STAFF RECOMMENDATION 2129 Belmont Boulevard April 17, 2019

Application: New Construction- Addition; Setback Determination
District: Belmont-Hillsboro Neighborhood Conservation Zoning Overlay
Council District: 18
Base Zoning: R8
Map and Parcel Number: 10416009600
Applicant: Matt McCrary, Allard-Ward Architects
Project Lead: Jenny Warren, jenny.warren@nashville.gov

Description of Project: Application for the construction of a rear addition, including a left side setback determination.

Figure 3 & 4: Ashwood Avenue elevation windows to be altered

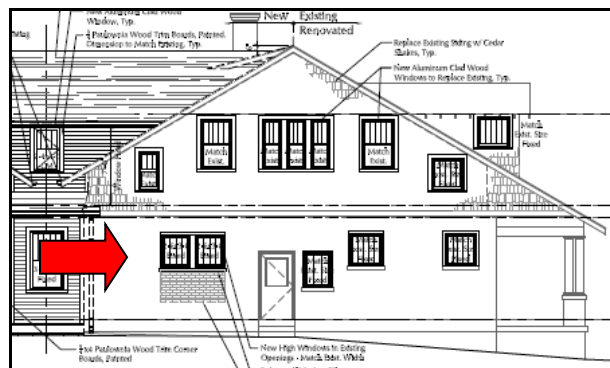
On the side elevation facing Ashwood Avenue, the applicant proposes to alter two original window openings, which is considered partial demolition. The two windows in question are paired, full height 4/1 windows. The applicant is proposing to shorten the height of the windows to create high paired windows that are fixed. As this work is beyond the midpoint of the historic house, staff finds that the window alteration could be appropriate in this situation.

Staff finds that the proposed partial demolition meets section V.2. for appropriate demolition.

Figure 7: Proposed addition in relation to property line and curb.

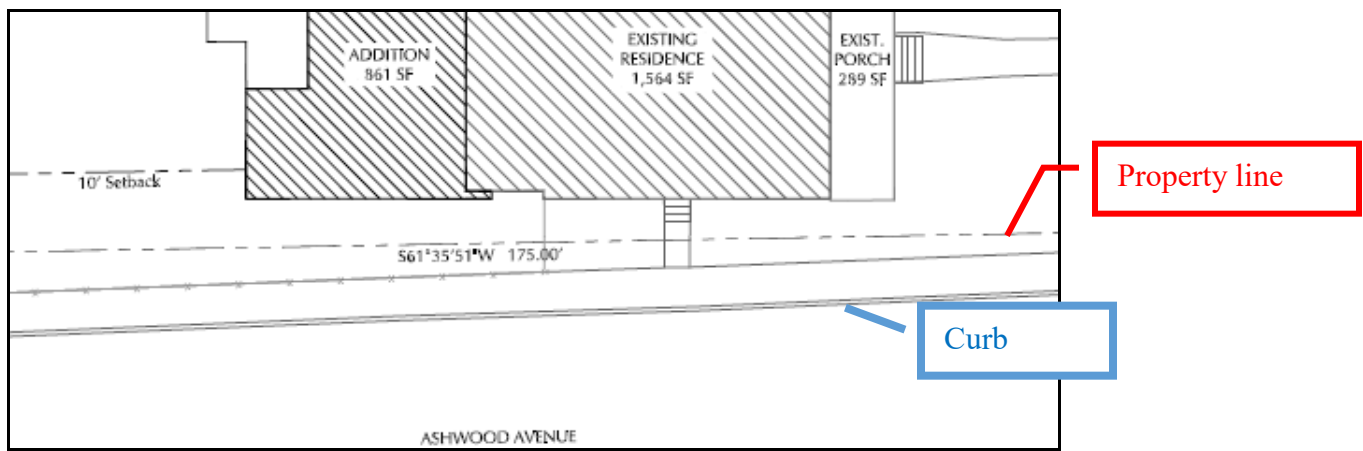
On the left side, along Ashwood Avenue, the proposed addition will be about six feet (6’) from the side property line, while zoning requires a ten foot (10’) side setback for corner lots. Staff is supportive of this setback request for several reasons. The addition lines up flush with the historic house and does not further encroach into the setback. The house sits on the lot at a slight angle as compared to the property line, so at its closest point, the front porch of the house currently sits only about four feet, six inches (4’6”) from the property line. Due to the angle of the house, the addition will sit back further than this, at about six feet (6’) from the property line. Further, the property line sits several feet from the street, meaning that the addition will sit fourteen to sixteen feet (14’-16’) from the curb (Figure 7).

Staff finds that the project meets section II.B.1.c for setbacks.
